April 3, 2024

IDEA Public Schools Upper RGV Mechanical Upgrades CSP#23-URMU-0424

ADDENDUM NO. 2

SHEET: ME2.1

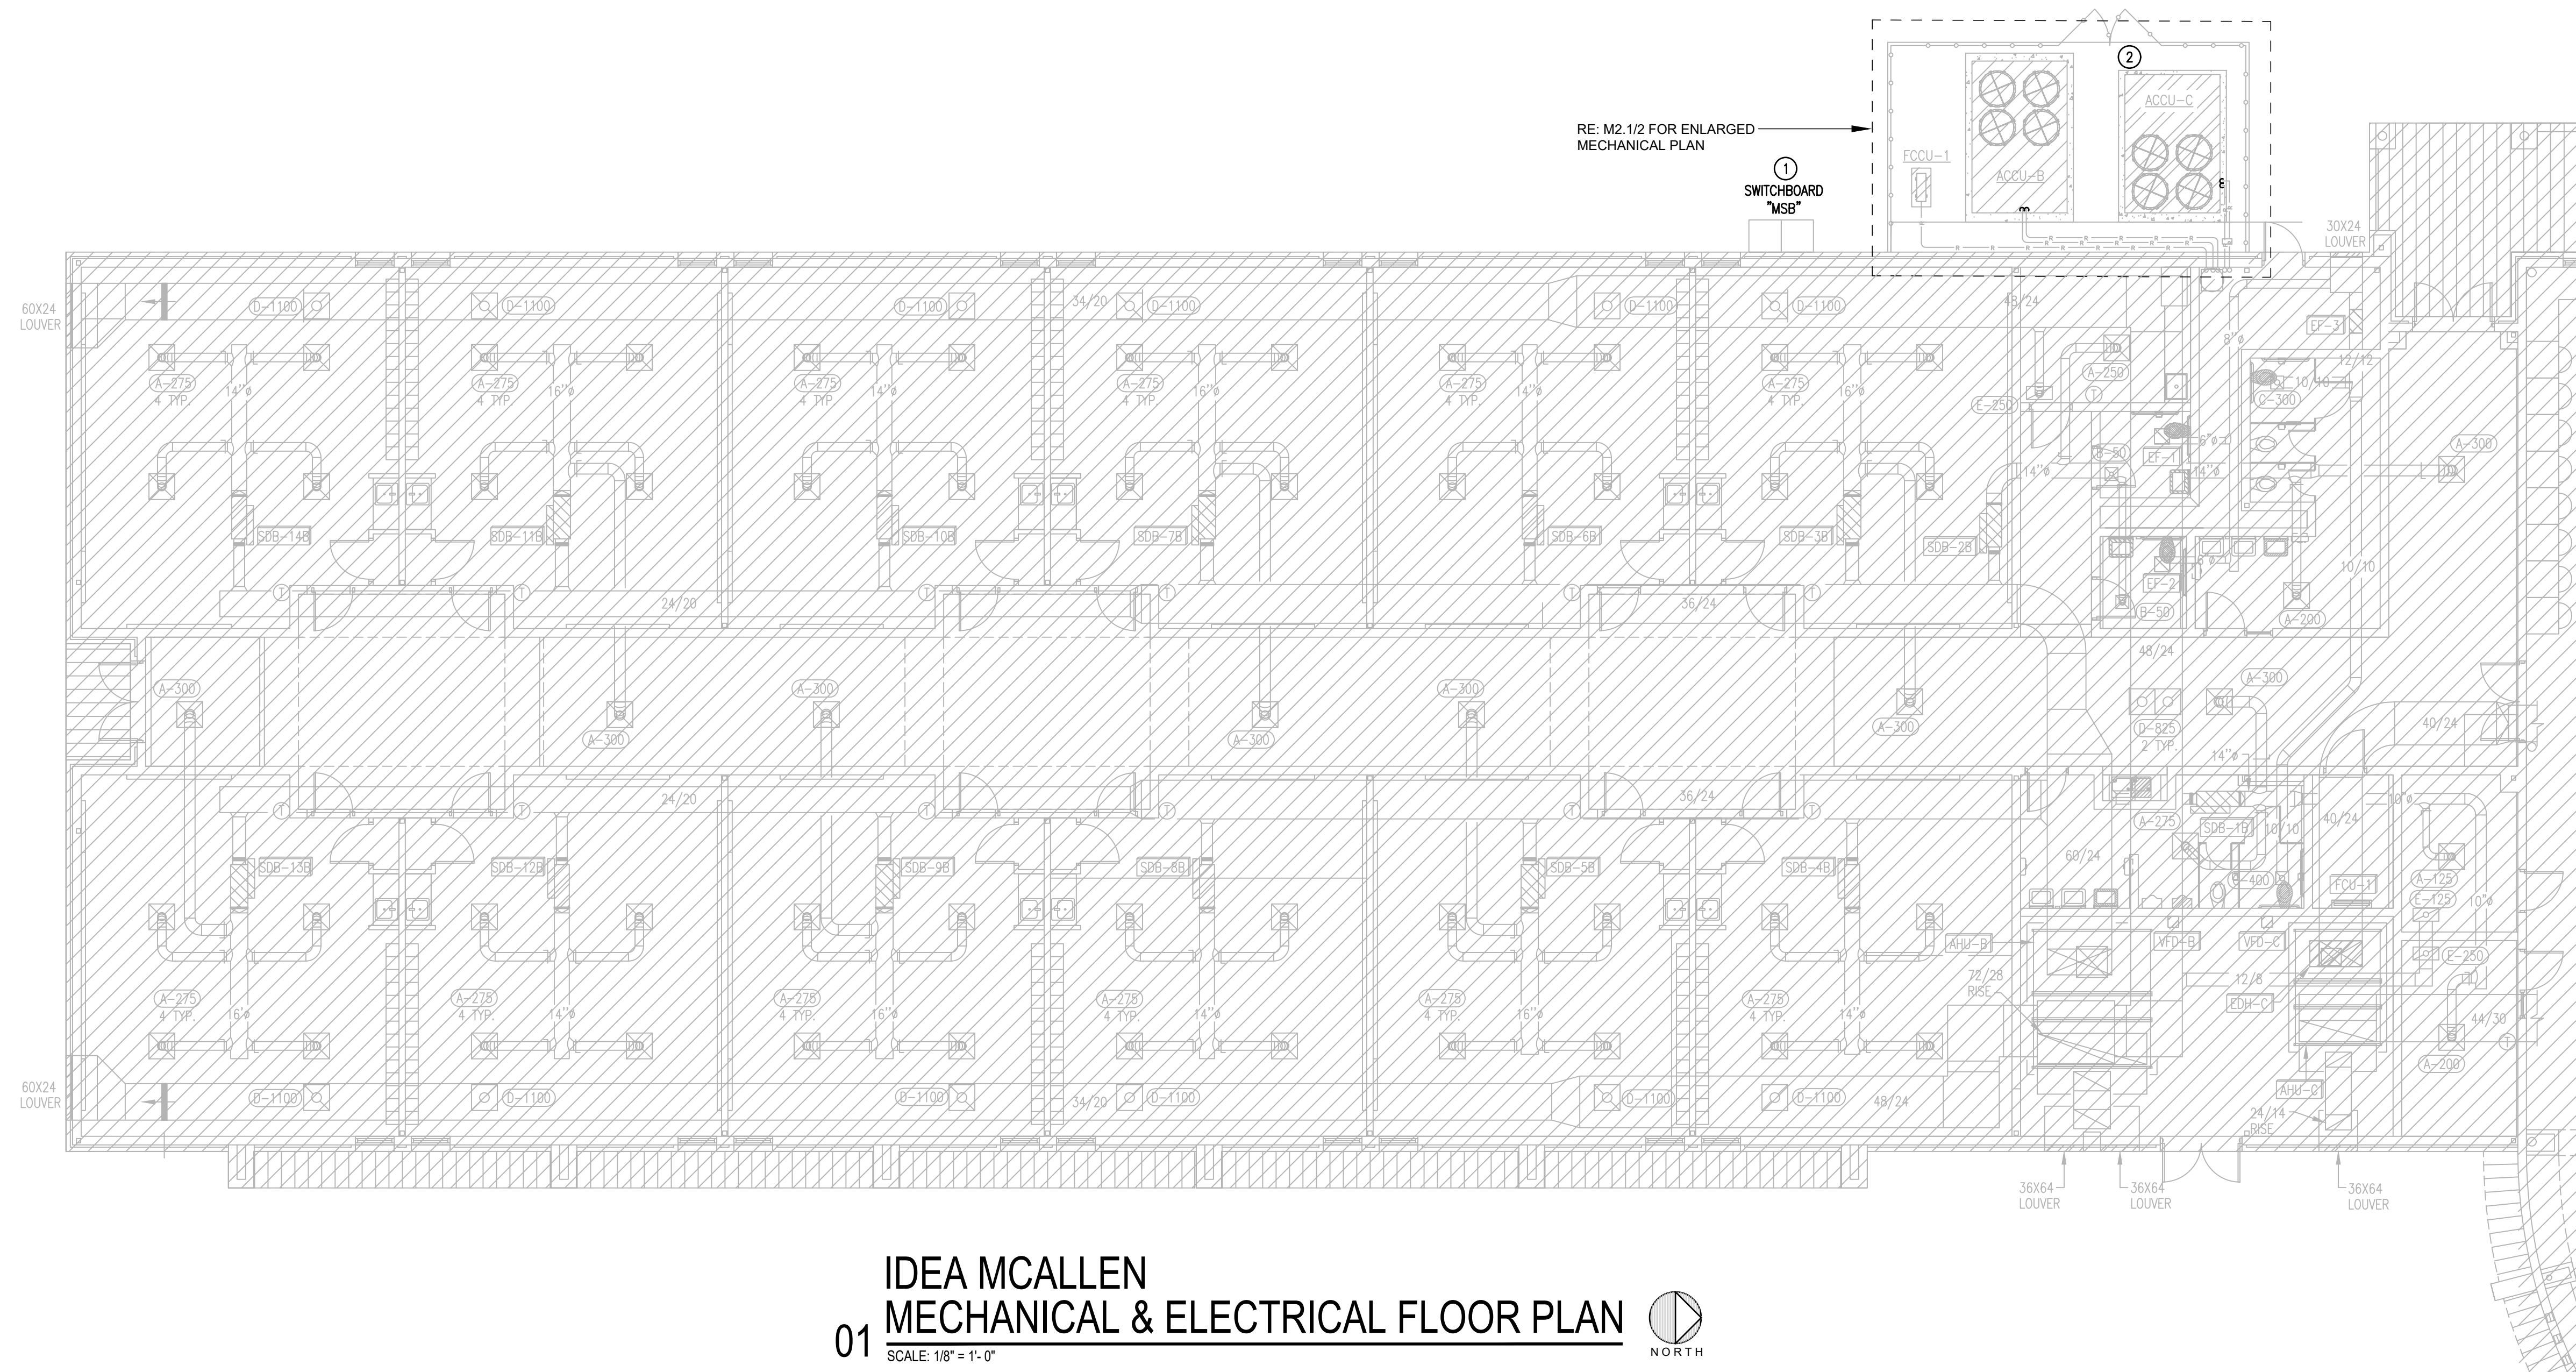
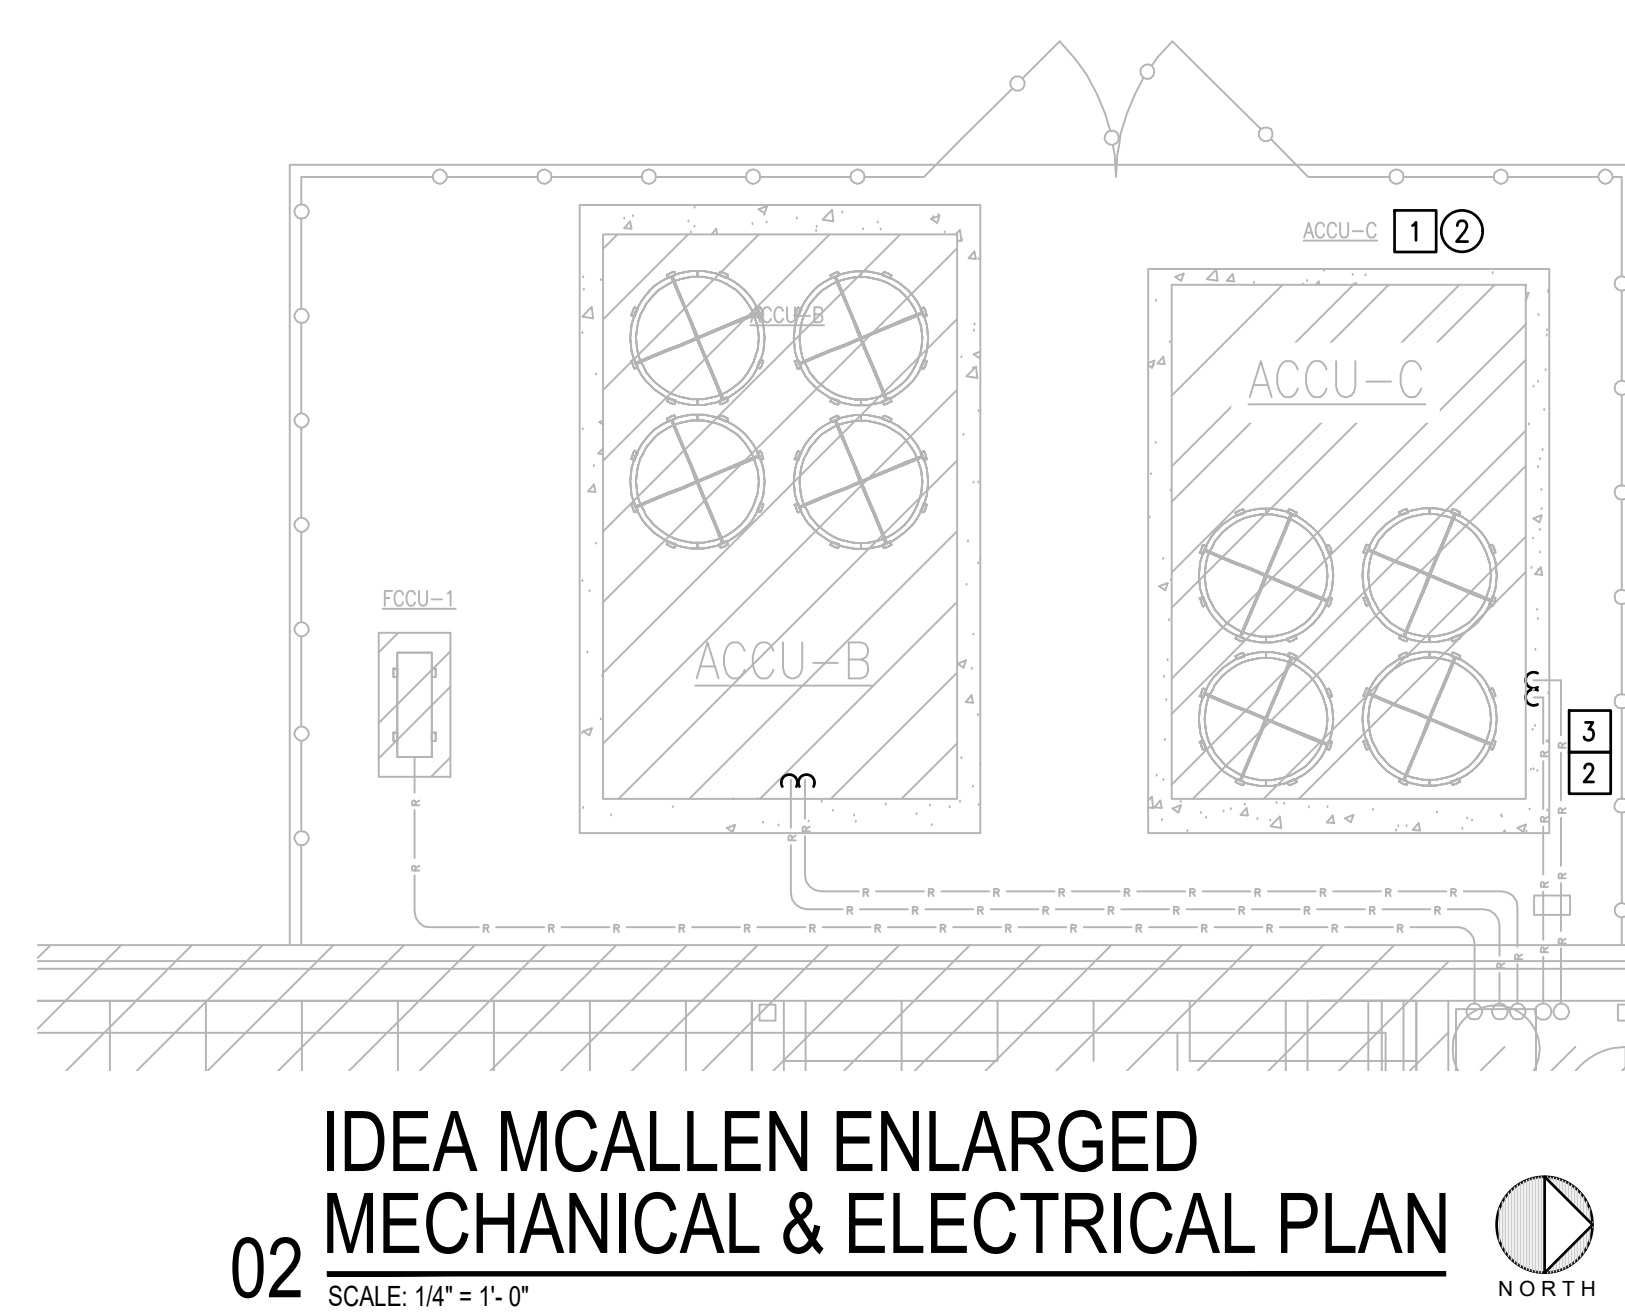
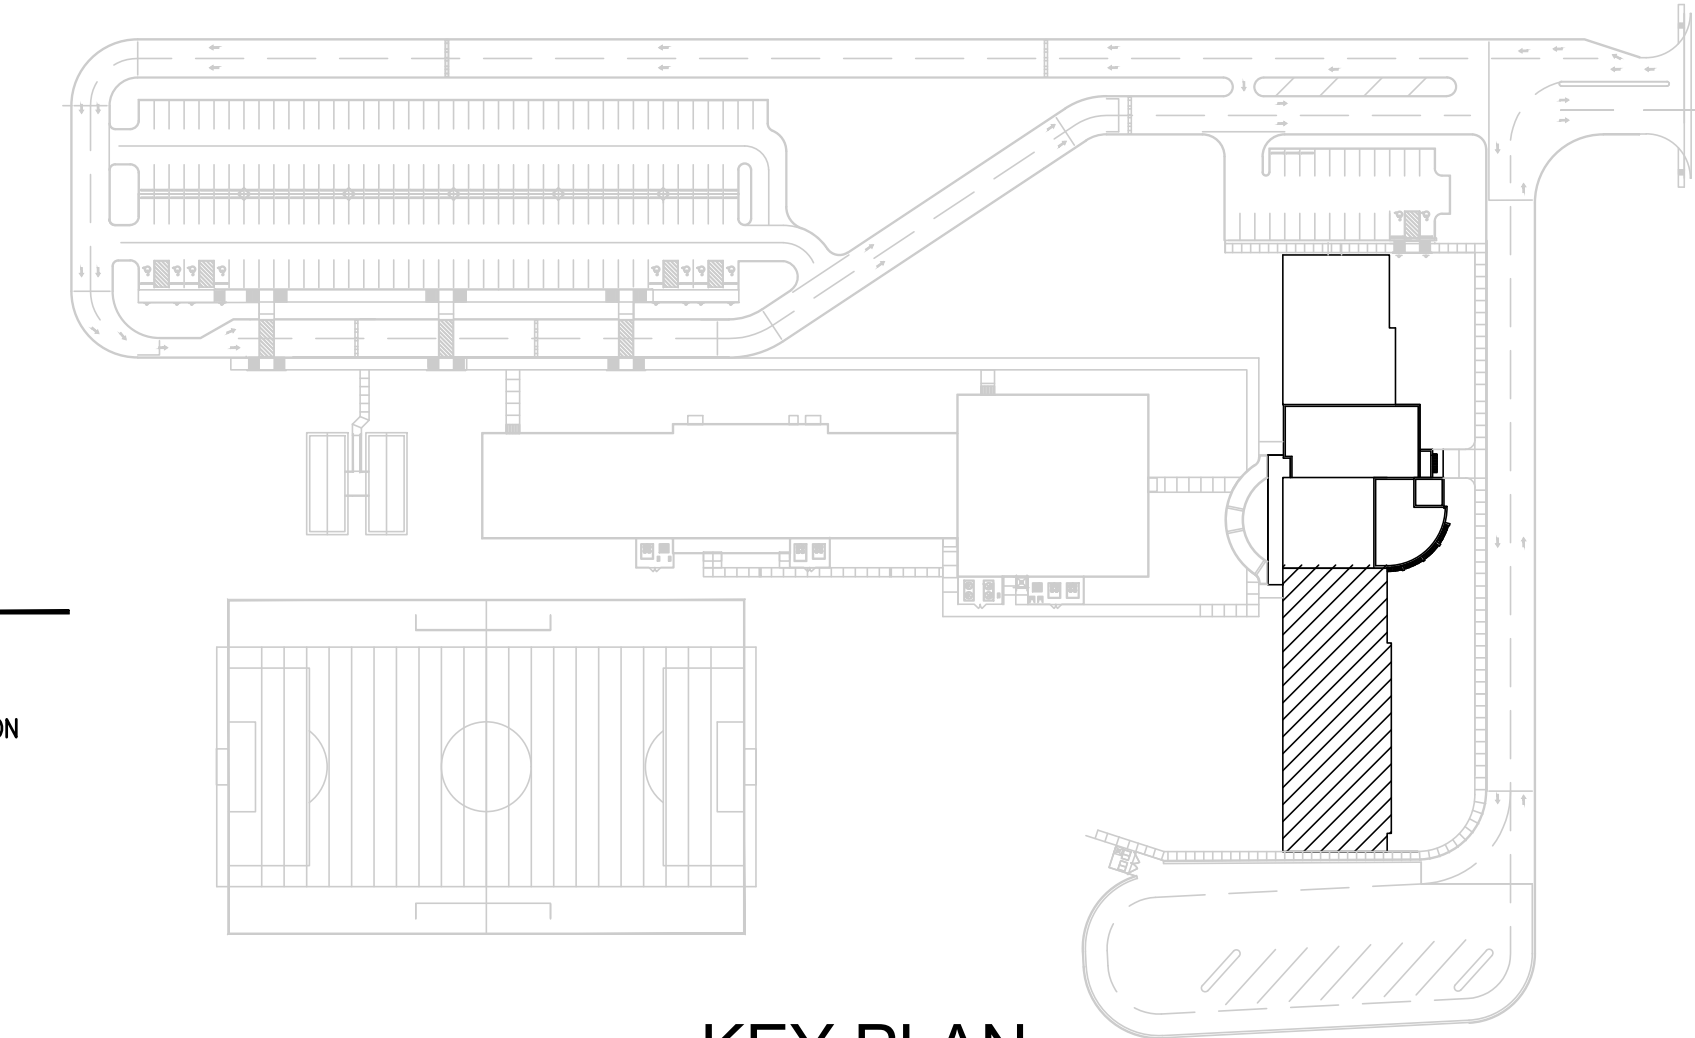
1. Sheet ME-2.1 – See attached.
 - a) Added Base Bid identification to schedules.
2. Sheet ME-2.2 – See attached.
 - a) Added Base Bid identification to schedules.
